Technical News Bulletin

Steinhausen, February 2024

FlexIS Drive Replacement

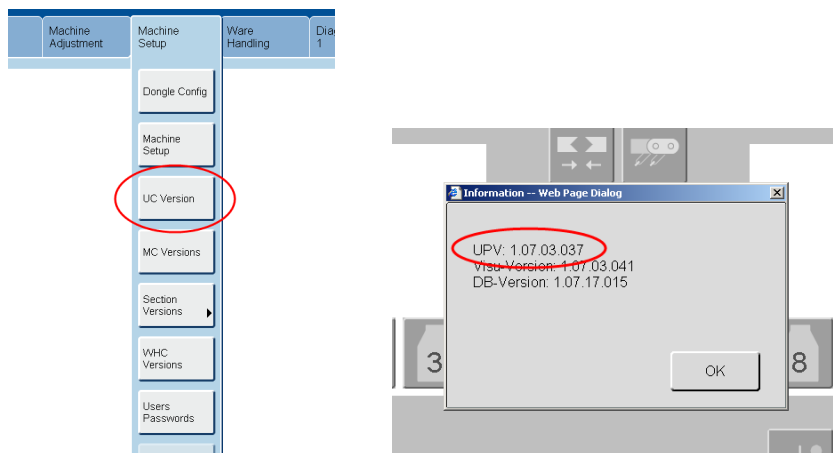
The dimensions and mounting of the drives remain unchanged.

The newest drives require following FlexIS Software Version (Update Package Version):

- FlexIS1: 2.11.00.010 and higher
- FlexIS2: UC2 Version 2.35-release-1185 and higher
- FlexIS3: UC2 Version 3.03-release-1351 and higher

X73
Safety (STO) input

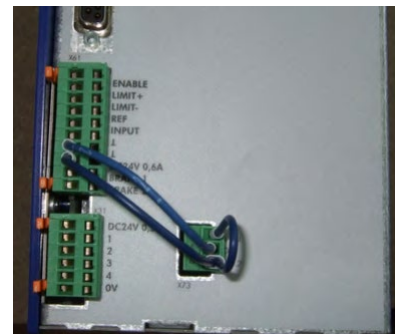
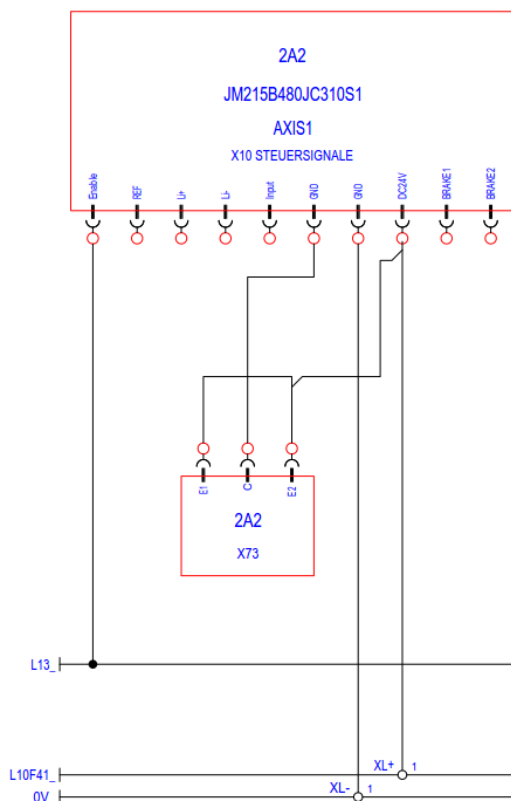
All new drives have a safety input to safely disable the drive (STO = Safe Torque Off). The old JetMove JM-215 (601-10146) does not have this safety input.

When replacing a JetMove JM-215 (601-10146) by a new model, it is necessary to add some wiring to enable this safety input: this input must be powered with 24 VDC.

Below you can see how to wire the safe enable input:

- Enable1 (E1) and Enable2 (E2) are connected to 24 VDC which can be taken from the 24V supply of the drive.
- COM (C) is connected to 0V which can also be taken from the 0V supply of the drive.

601-20103
